Access Compliance Report

Public Rights-of-Way

(Curb Ramps)

Intersection ID: 52448	Main Street: WOODWARD_AV	Cross Street: DOUBLE_OAKS_RD	Location: SE
ADA ID: A255C19597AB	Ramp Type: Directional1	Initial Pass/Fail: Fail	Overall Compliance: No
Severity Score: 13.75			
Codes/Mitigation Info/Possible Solution		Field Measurements/Component Compliance

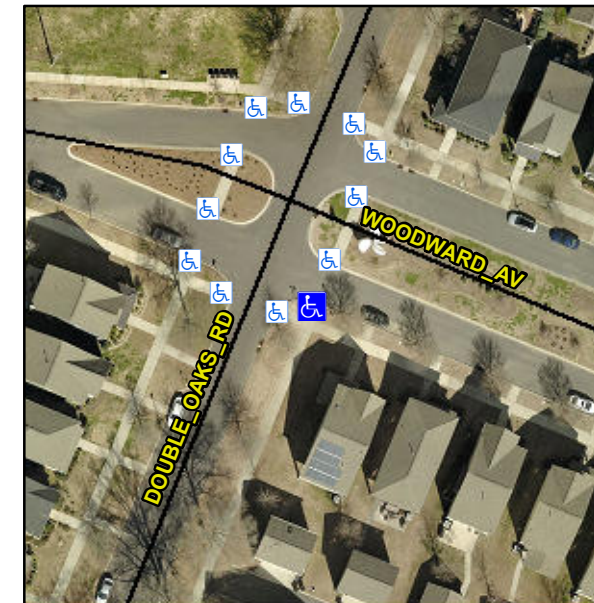
R304.2.2, R304.5.3

Remove & Replace Entire Ramp.
